**BULLETIN #:** 19M-01

**SUBJECT: Obsolescence of 5F (New only) Compressor Models**

**Description: Suspension of NEW 5F compressor production**

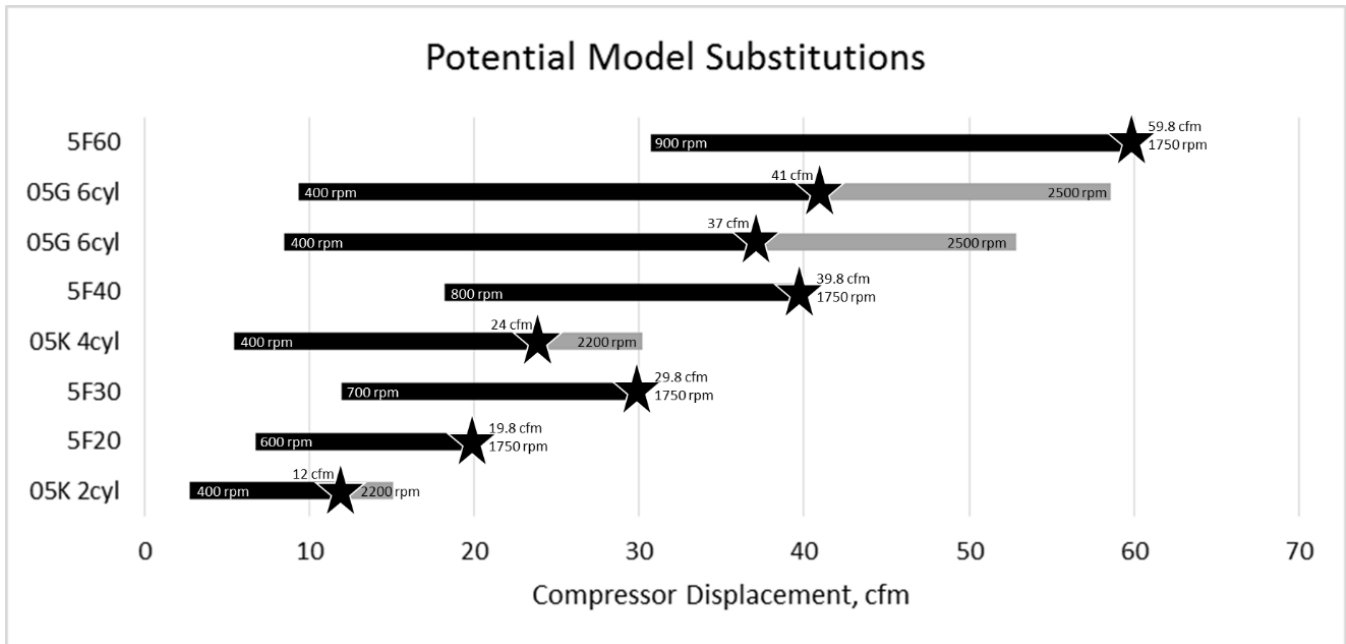
The figure below shows potential model conversion options to the existing 05K and 05G compressor platforms. Any belt driven applications should find a replacement model that has the same compressor displacement (i.e. capacity) as the legacy 5F model. However, this may be at a different compressor speed necessitating different pulley ratios on the drive system. Direct drive applications may require variable speed drives in order to compensate for these displacement differences.
